Date: August 7, 2009 No. B-2051

Service Bulletin

Product Family: 986101 Lawn Edger

Subject: 03729851 Cutter Head Spindle

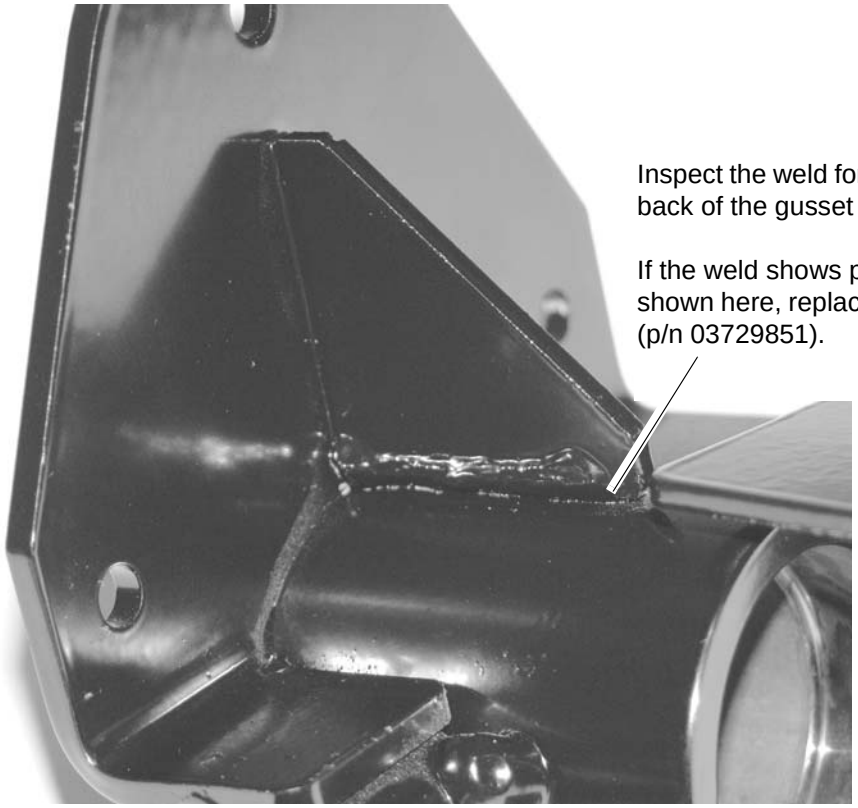
Ariens Company has learned that the gusset weld on the cutter head spindle (p/n 03729851) used on the 986101 Lawn Edger in the above-listed serial number range may not have adequate penetration to support the blade guard mounting flange. These welds have the potential to fail prematurely, causing the guard mounting flange to break.

Inspect the weld for good penetration on the back of the gusset along the spindle.

If the weld shows poor penetration, as shown here, replace the cutter head spindle (p/n 03729851).

Ariens Company has changed the welding process on this part to improve weld consistency and ensure proper support for the flange.

Dealers should replace the cutter head spindle p/n 03729851 on all unsold inventory of Lawn Edger 986101 before putting the machine into service.

For units that are already sold, whenever the machines come in for any service or maintenance of any kind, inspect the gusset weld at the location identified in the illustration on page 2. If the weld shows signs of inadequate penetration, replace the cutter head spindle.
